Singing Arrow Community Center
 Administrative Amendment Request
 Project # PR-2018-001760

Contact: Nilo Salgado-Fernandez, 924-3630, nsalgado-fernandez@cabq.gov

Transportation Development Comments:		
	COMMENT	RESPONSE
1	Provide a turning template exhibit for the Refuse truck traversing around semi-circular island to ensure there will be no damage to Island infrastructure which includes site lighting, curb and gutter, the top surface of the Island and outer curbing parameters. Providing a typical section of the semi-circular will answer a lot of my concerns.	Per DPM Section 7-4(K)(17).3, "Where the aisles will function for deliveries by larger trucks, refuse, and/or fire vehicles, a 25' radius or larger shall be used. Turning radius provided throughout parking lot is 28'-0" minimum, including at the semi-circular parking islands. Drive aisle is minimum of 24'-0" wide throughout. None of the dimensions of the drive aisles or islands have changed since the drawing set was reviewed during the EPC process, nor during the permitting process. Both the Fire Marshal and the Solid Waste Department have run templates on the plans and approved the layout.

PARTIAL SITE PLAN

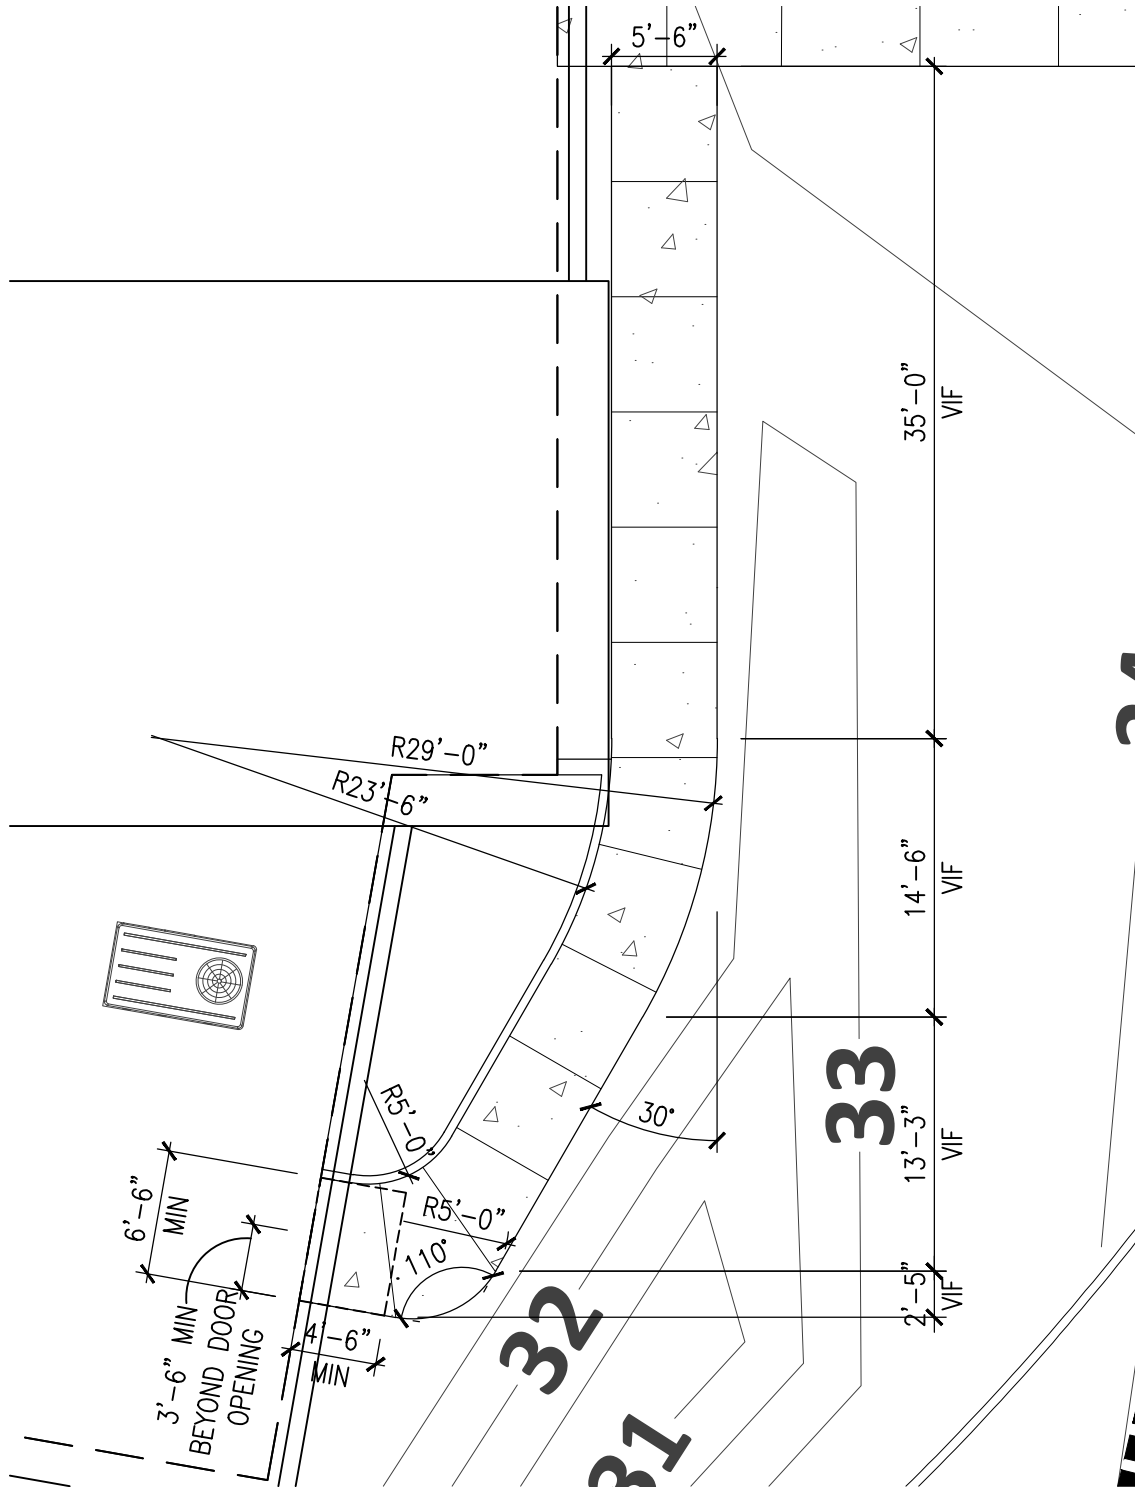
Per RFI #054, it was determined that exterior door 121B is to be a left-hand swing door, to allow for improved anchoring of the door for better strength and durability of the assembly.

Reconfigure concrete walkway outside of door 121B to meet all ADA accessibility requirements per attached sketch, SK#A.

****Note: Concrete walkway must meet the minimum grade requirements for ADA accessibility. Cross slope of path to be not steeper than 1:48 (2%).**

SINGING ARROW COMMUNITY CENTER ENLARGED SITE PLAN
 SCALE: 1" = 30'-0"

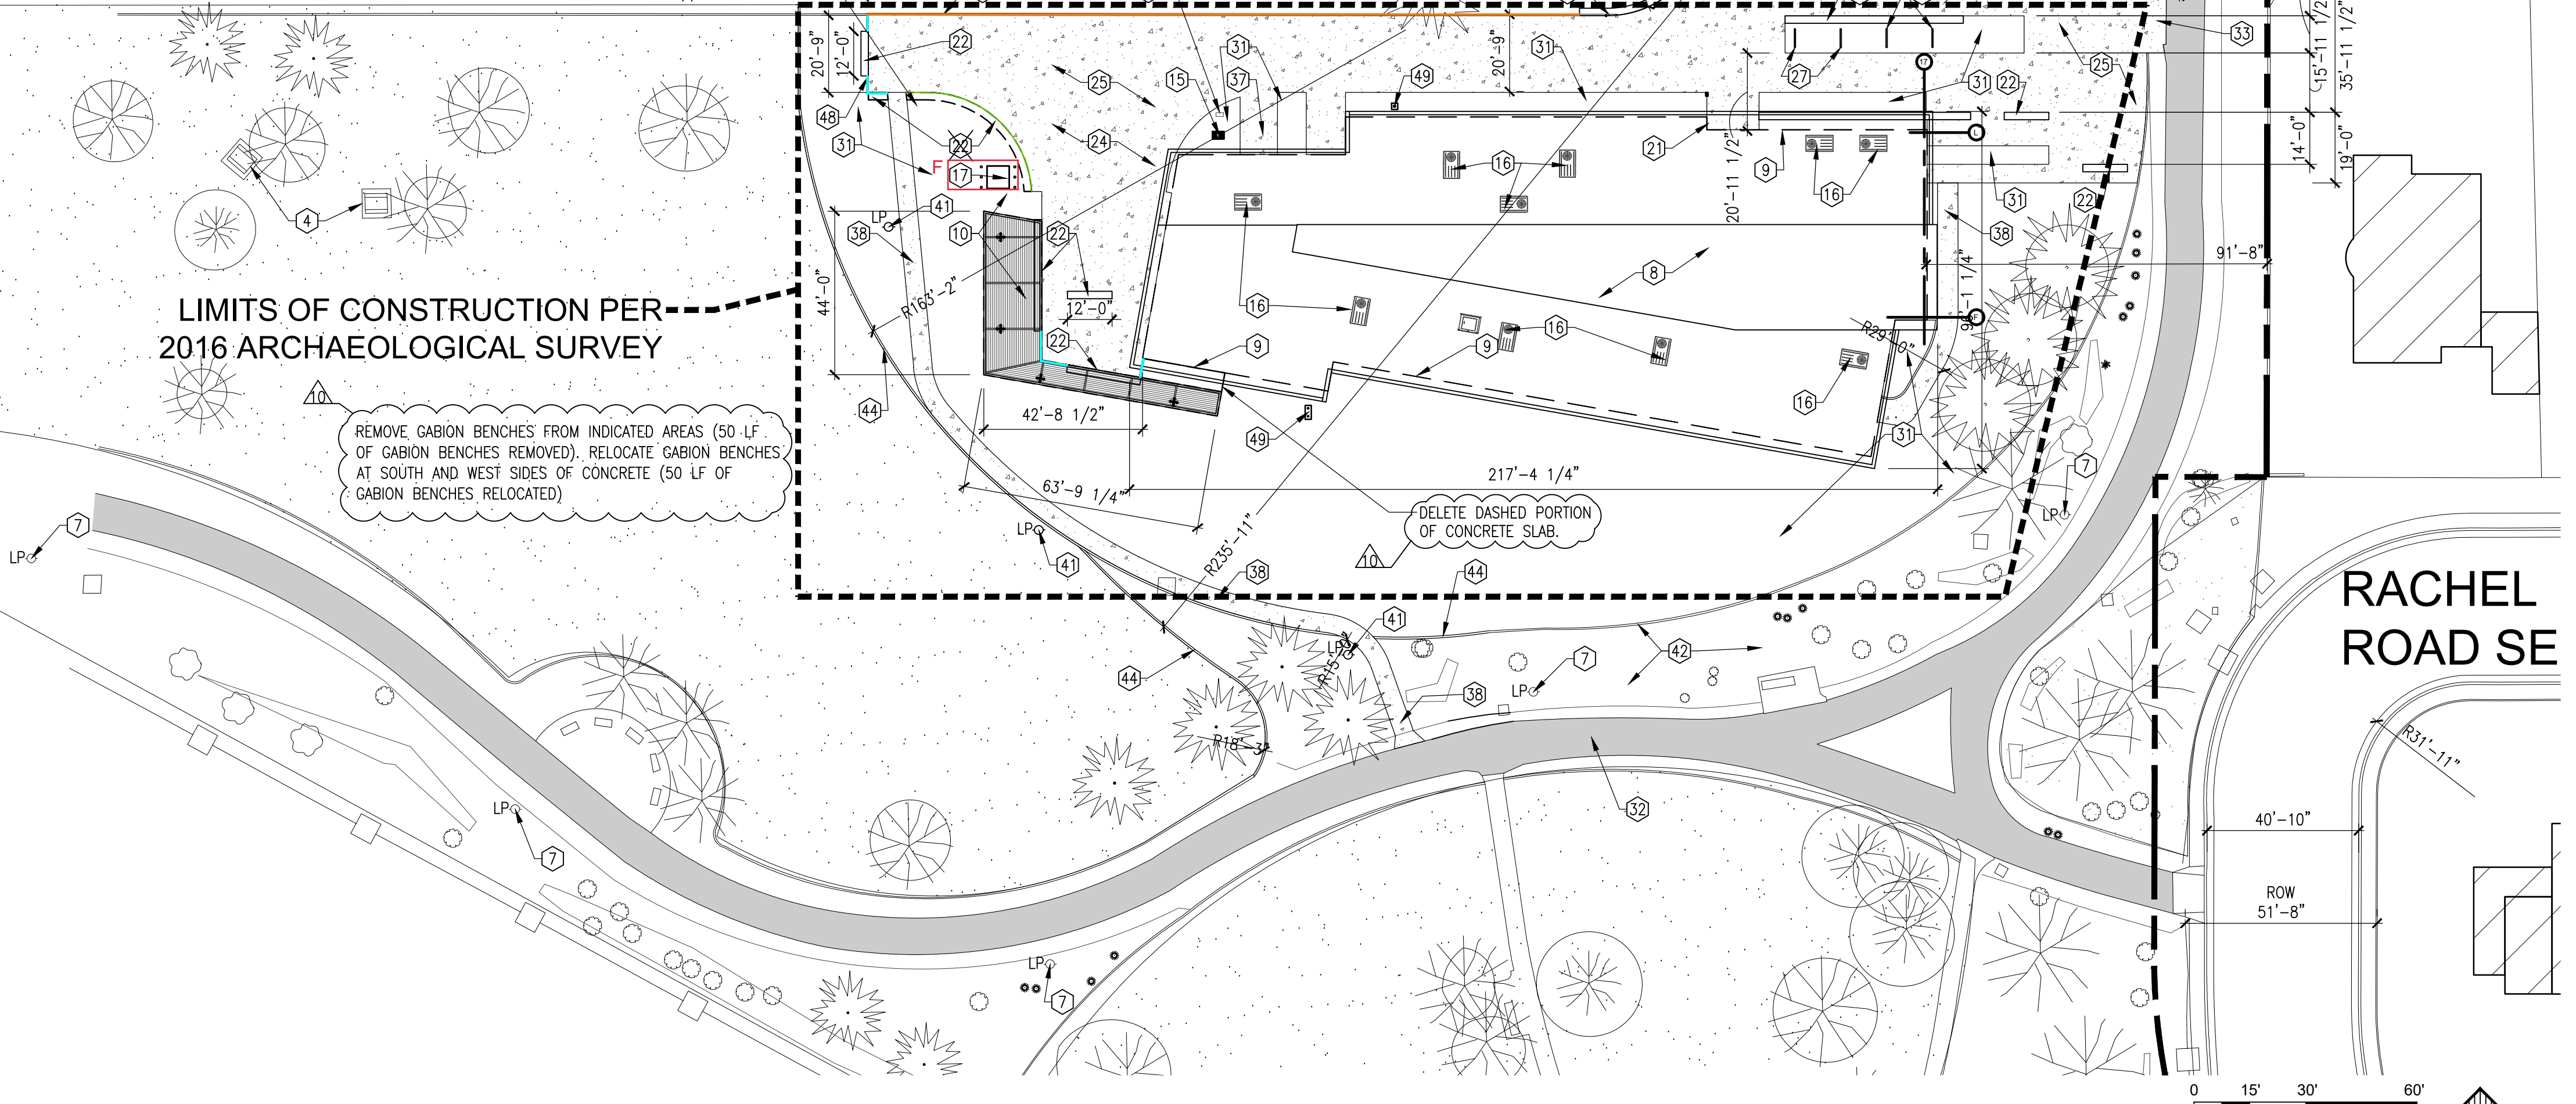
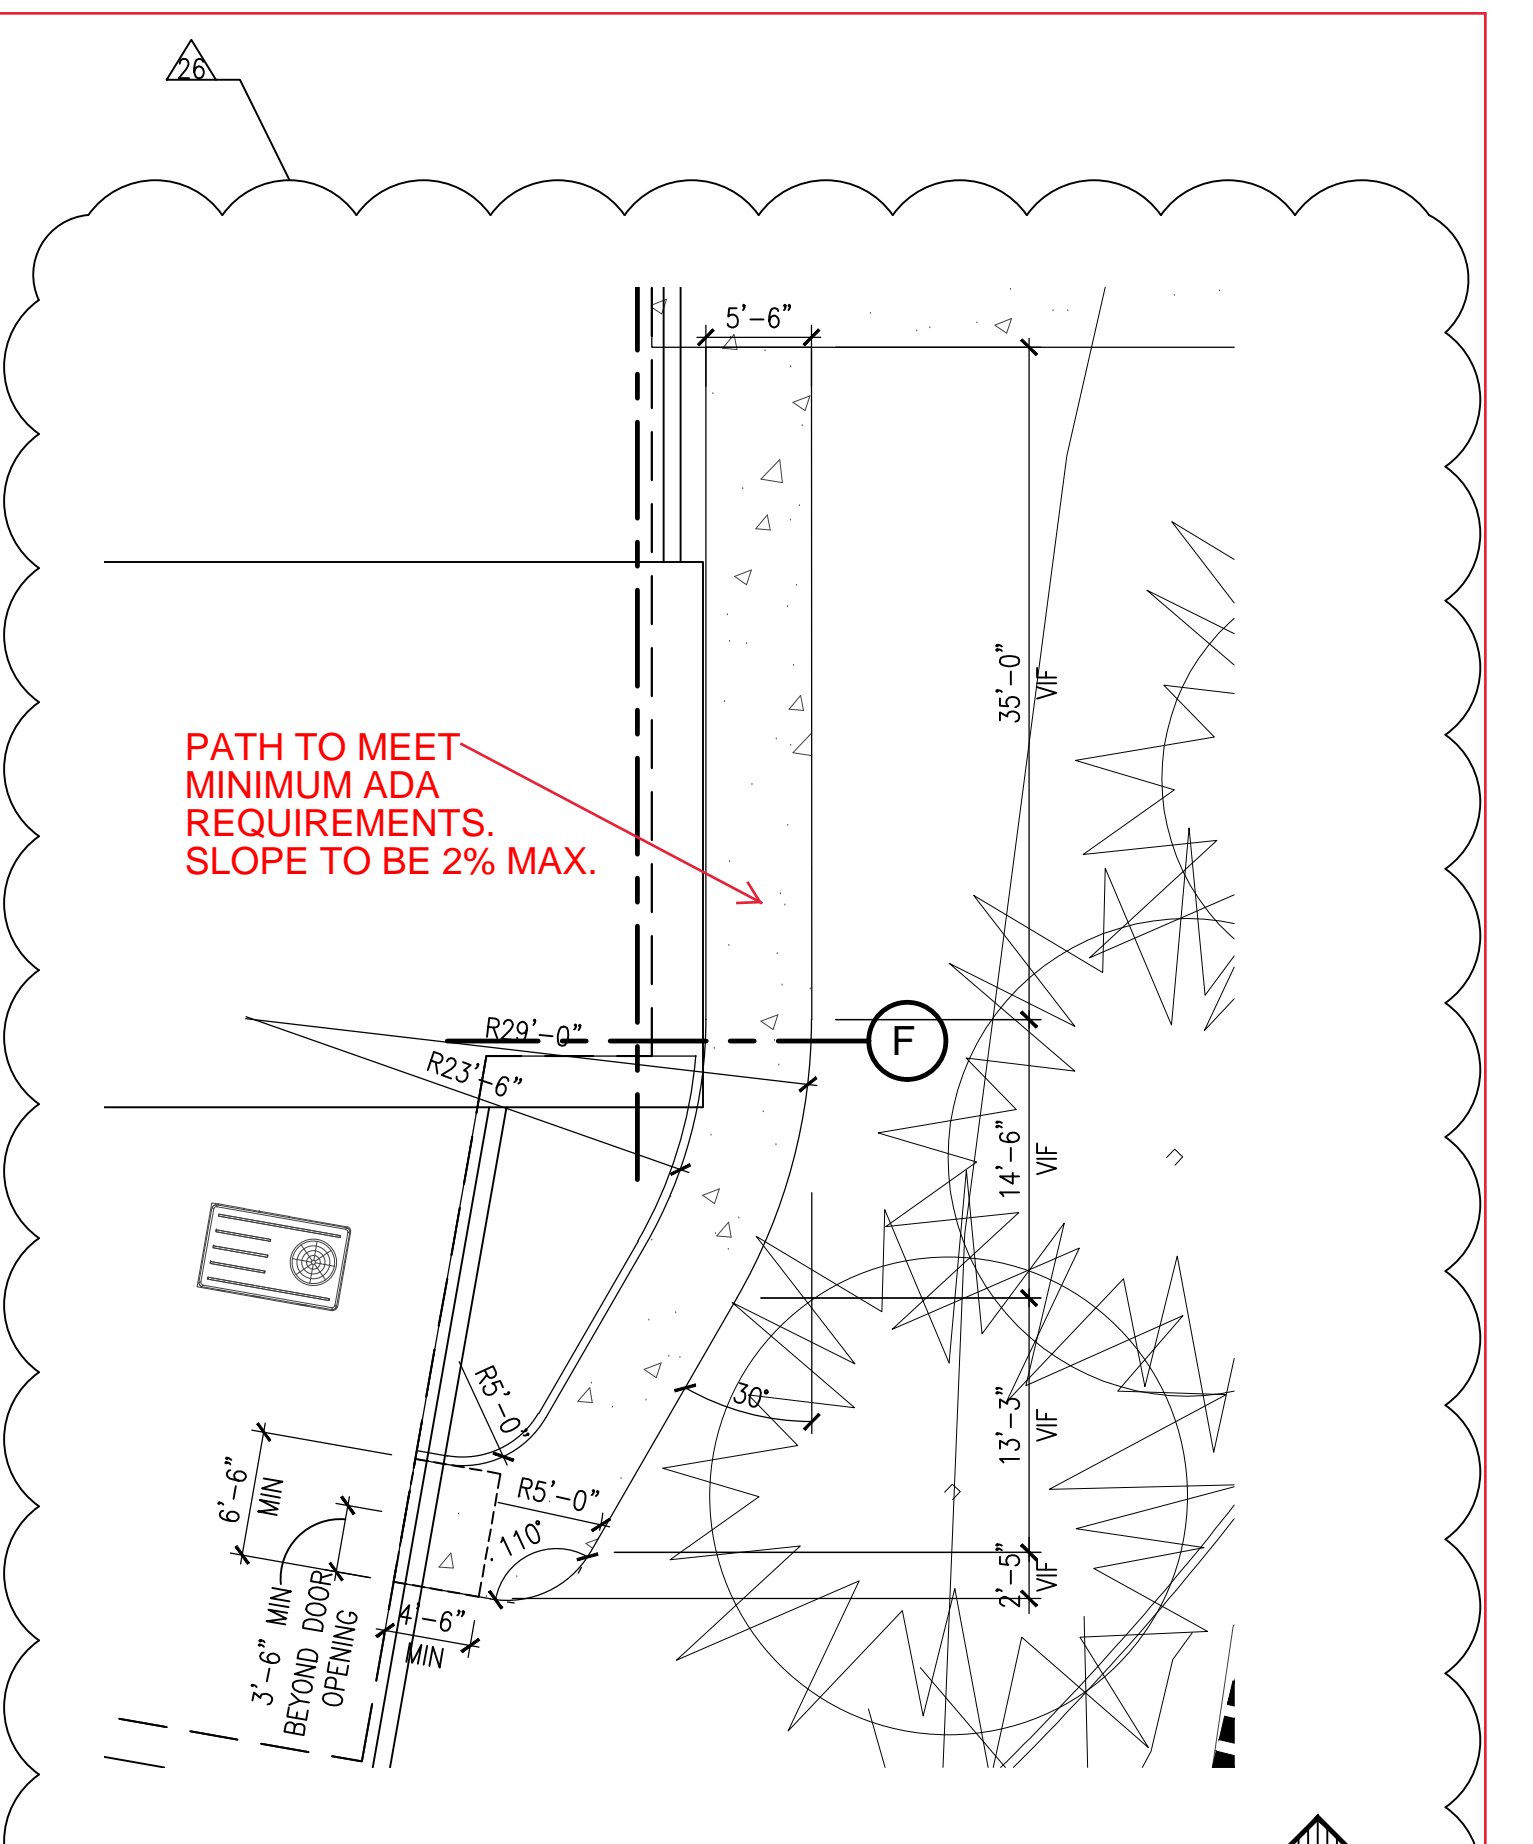
10	Call out any bollards, parking bumpers and handicapped signage on the plans as applicable.	All bollards, and handicapped signage called out on AS102 in Sheet Keynotes. Parking bumpers shown typical at all parking spaces, but not called out by Sheet Keynote, to maintain clarity of drawings. Parking bumper detail provided at E4/AS501. Only the bollards immediately adjacent the refuse enclosure are changed as part of this Administrative Amendment.
11	Motorcycle parking stalls: Label stalls MC.	The motorcycle spaces are unchanged as part of this Administrative Amendment. Per DPM Section 7-4(K)(3).3, motorcycle spaces shall be designate with a posted upright sign, either free standing or wall mounted. Each sign shall be no smaller than 12" x 18" and shall have its lower edge no less than 4'-0" above grade. Signs are called out per Seet Keynote 47 on AS102.

B2 ASS01 REFUSE ENCLOSURE ENLARGED PLAN
 SCALE: 1/2" = 1' - 0"

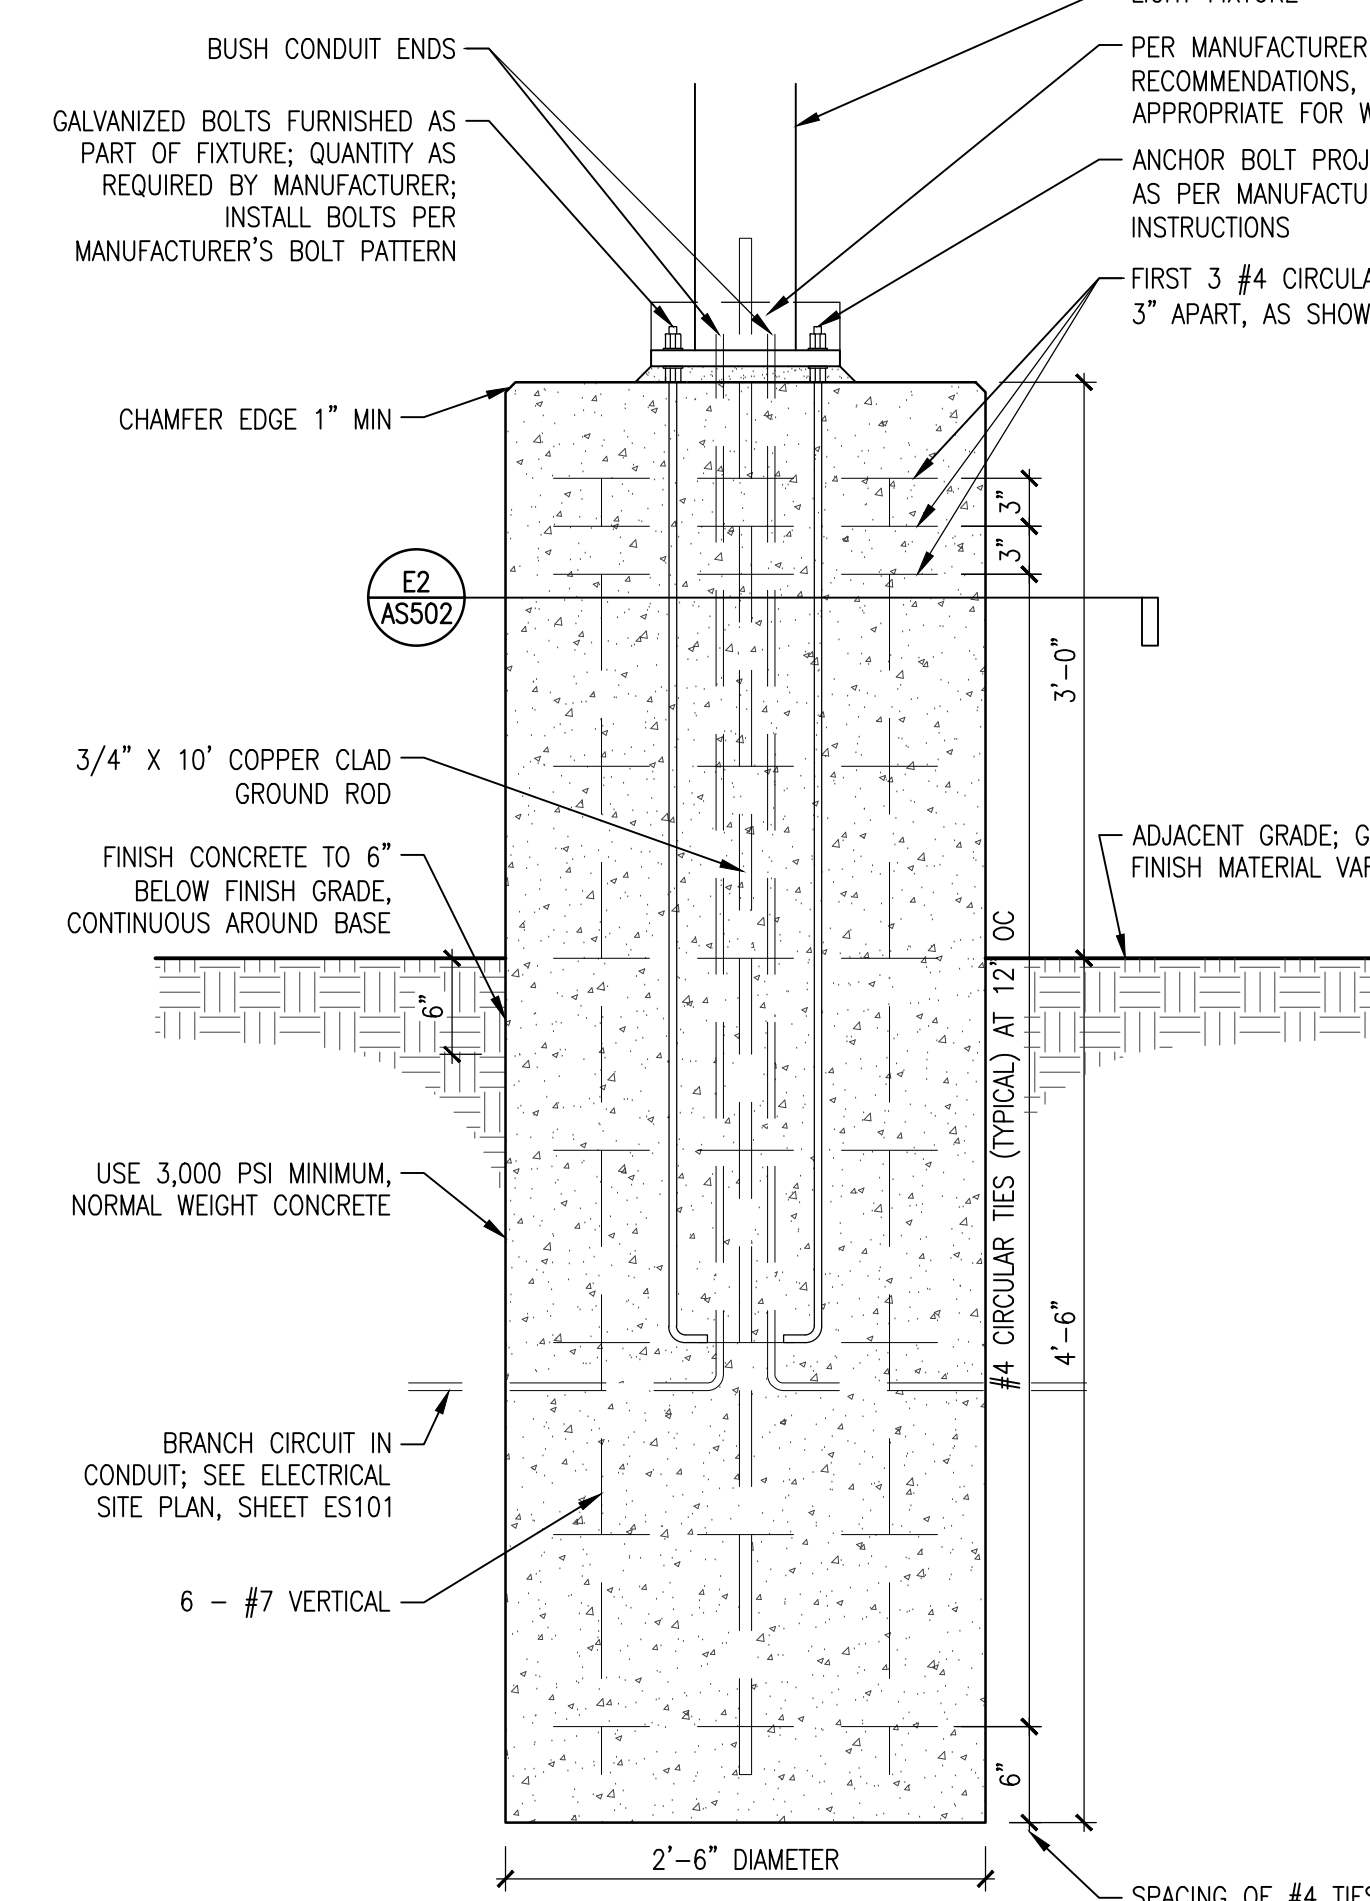
2	Will the new location of refuse container encroach into driving aisle? Please verify and dimension the outer edge of the refuse container and parking stall opposite to the container to determine the clearance/spacing of drive aisle.	No. Drive aisle is not affected by the new location of the refuse enclosure. Drive aisle remains 24'-0" wide, as was included on approved Site Plan. 24'-0" dimension was included on the AS102 Site Plan that we submitted. See highlighted dimension on attached plan.
3	You have stated in modifying curb! So, provide detail on the curb modification since sheet AS502/B5, C5, E4) have not been provided. On island curbing are you providing concrete behind header curb to enforce the structural integrity?	The updated Sheet AS501 and Sheet AS502 have been provided with all curb details.
4	Paint the proposed bollards yellow.	See attached sketch, Enlarged Refuse Enclosure Plan. This has been issued to Contractor as ASI #31 Rev, to call for bollards by refuse enclosure to be painted traffic yellow.

Per comments received from COA Transportation Review, new bollards by refuse enclosure to be painted "Traffic Yellow".

See revised Refuse Enclosure Enlarged Plan, attached for more information.
